UNITED STATES  
NUCLEAR REGULATORY COMMISSION  
REGION V  
1990 N. CALIFORNIA BOULEVARD  
SUITE 202, WALNUT CREEK PLAZA  
WALNUT CREEK, CALIFORNIA 94596

IE Bulletin No. 80-20

FAILURES OF WESTINGHOUSE TYPE W-2 SPRING RETURN TO NEUTRAL CONTROL SWITCHES

FIGURE 1

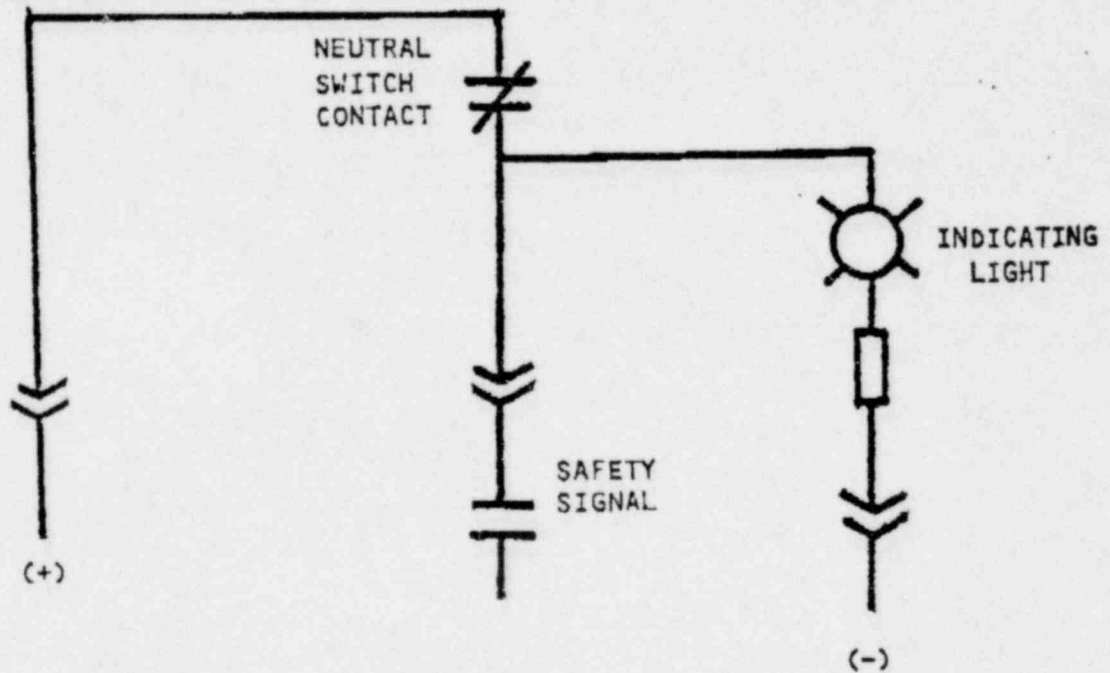
A review of this matter by Westinghouse led to the issuance of NSD Technical Bulletin No. NSD-TB-80-9 to the utility owners of all Westinghouse operating plants. The recommendations contained in the Westinghouse technical bulletin include: (i) testing the neutral position contacts of the subject W-2 switches for continuity, and (ii) rewiring of the indicating light circuit to permit the early detection of a neutral contact failure as shown in Figure 1.

Depending on how the indicating light circuit is wired, loss of continuity thru the neutral position contact of a W-2 switch could remain undetected until the equipment associated with the switch were called upon to operate. Since such a failure would be equivalent to by-passing the system associated with the switch, consideration should be given to rewiring the switches used in safety-related applications as shown in Figure 1. Such rewiring would provide an acceptable means for detecting contact failure, provided the indicating light is in the control room and readily visible by the operator. If the indicating light is not so located, consideration should be given to annunciating the neutral position contact failures at the control room to alert the operator of the inoperable status of a safety-related system. In addition, consideration should be given to adding redundant contacts to the W-2 switches or to replacing the W-2 switches with others having a more positive contact wiping action.

3. Licensees of operating plants and holders of construction permits shall describe the longer term corrective measures planned and the date by which such measures will be implemented by actual installation or by design change, as appropriate. As a minimum, the longer term corrective measures should include rewiring the indicating light as shown in Figure 1 provided the light is readily visible to the control room operator. If not, failures of the neutral position contacts should be annunciated in the control room.

EXISTING INDICATING LIGHT CIRCUIT (TYPICAL)

PROPOSED REWIRING OF INDICATING LIGHT CIRCUIT (TYPICAL)
